ADDENDUM NO. 3
February 4, 2025

2025 CARBON MONOXIDE
DETECTOR WORK IN
MULTIPLE BUILDINGS
JOLIET, ILLINOIS
FOR
JOLIET PUBLIC SCHOOLS DISTRICT 86
JOLIET, WILL COUNTY, ILLINOIS
PROJECT NO. 6-1324-32

ADDENDUM NO. 1
January 28, 2025

DIRKSEN JR. HIGH SCHOOL
FLOOR PLAN
1" = 30'
0 15 30 60 90

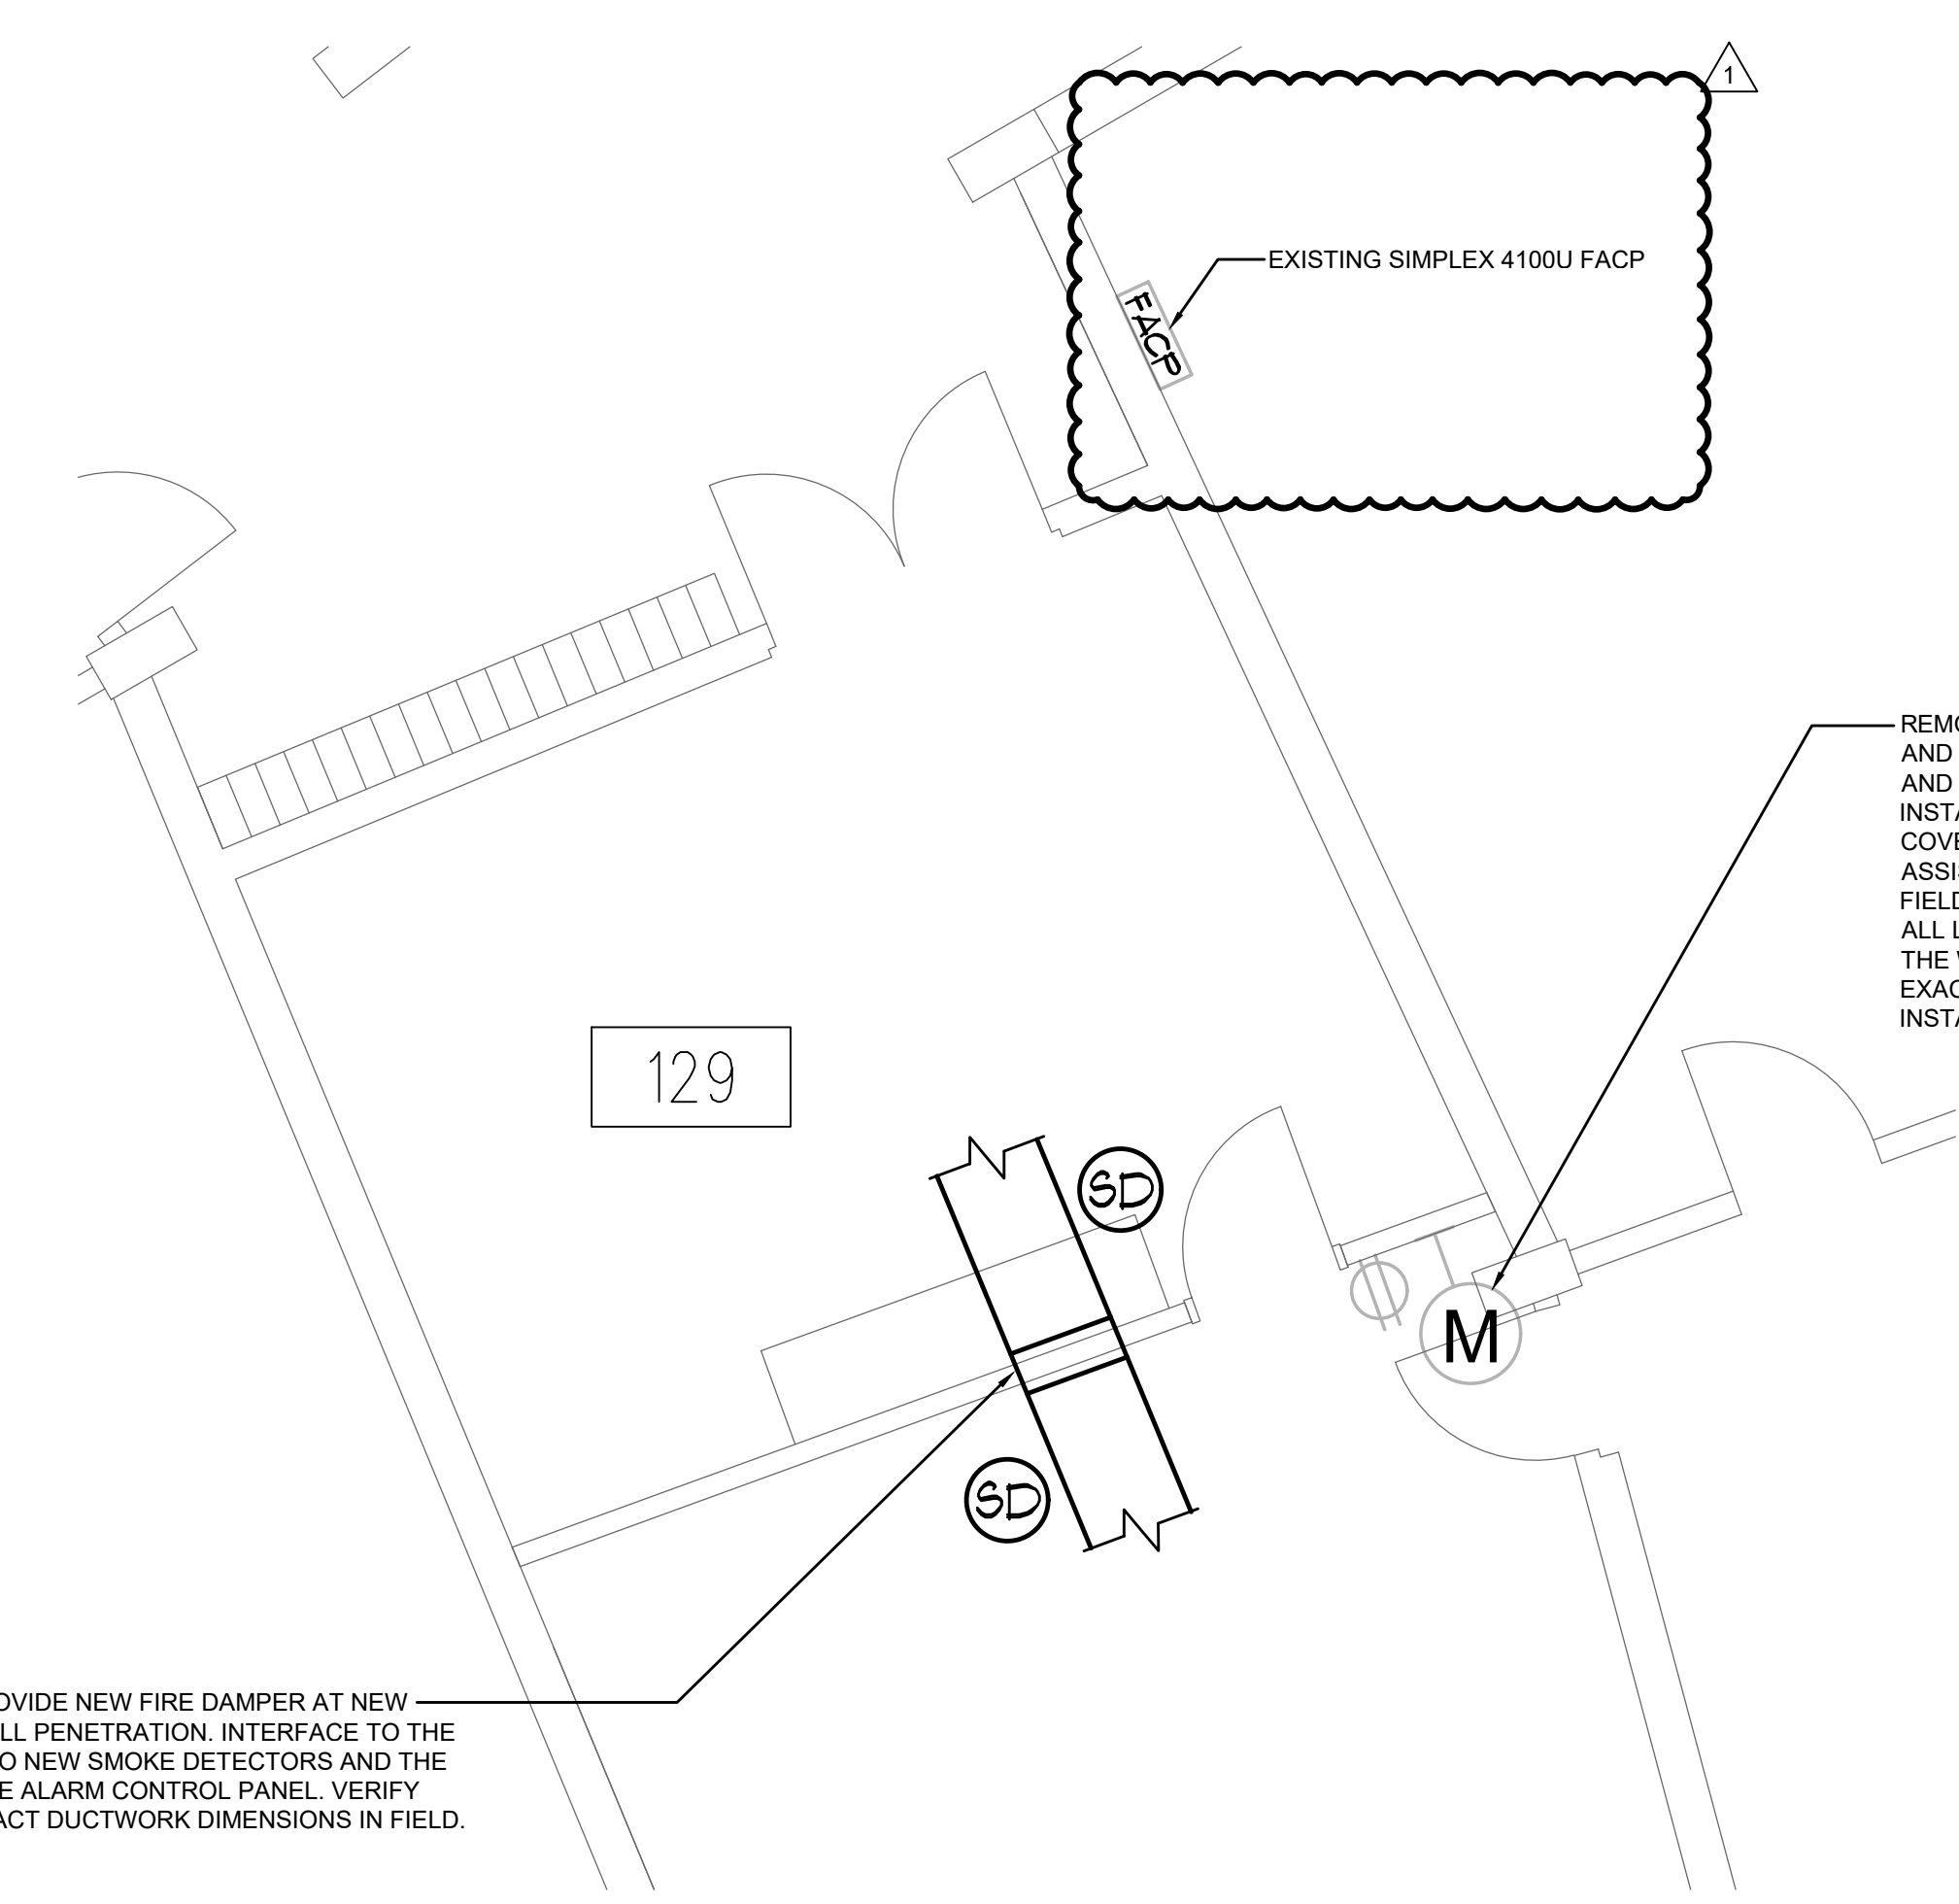
REMOVE AND REINSTALL ALL DEVICES ON BOTH SIDES OF THIS WALL BEING REMOVED AND REBUILT. REMOVE ALL CONDUIT AND WIRING BACK TO THE NEAREST JUNCTION BOX AND EXTEND NEW CONDUIT AND WIRING (MATCHING EXISTING) TO NEW DEVICE INSTALLED IN THE SAME LOCATION WITHIN THE NEW WALL. PROVIDE NEW OUTLETS AND COVER PLATES TO REPLACE THE EXISTING DEVICES. DEVICES SHOWN ARE FOR ASSISTANCE ONLY. VERIFY EXACT LOCATION, QUANTITY, AND TYPES OF DEVICES IN THE FIELD. ALL EXISTING PENETRATIONS SHALL BE MAINTAINED. PROVIDE PVC SLEEVES FOR ALL LOW VOLTAGE WIRING PENETRATIONS. PROTECT ALL WIRING ROUTED THROUGH THE WALL DURING CONSTRUCTION AND GROUP WIRING WHERE POSSIBLE. VERIFY EXACT QUANTITY AND LOCATION OF ALL PENETRATIONS WITH THE ARCHITECT PRIOR TO INSTALLING WITHIN THE NEW WALL. COORDINATE WITH ALL TRADES.

PROVIDE NEW FIRE DAMPER AT NEW WALL PENETRATION. INTERFACE TO THE TWO NEW SMOKE DETECTORS AND THE FIRE ALARM CONTROL PANEL. VERIFY EXACT DUCTWORK DIMENSIONS IN FIELD.
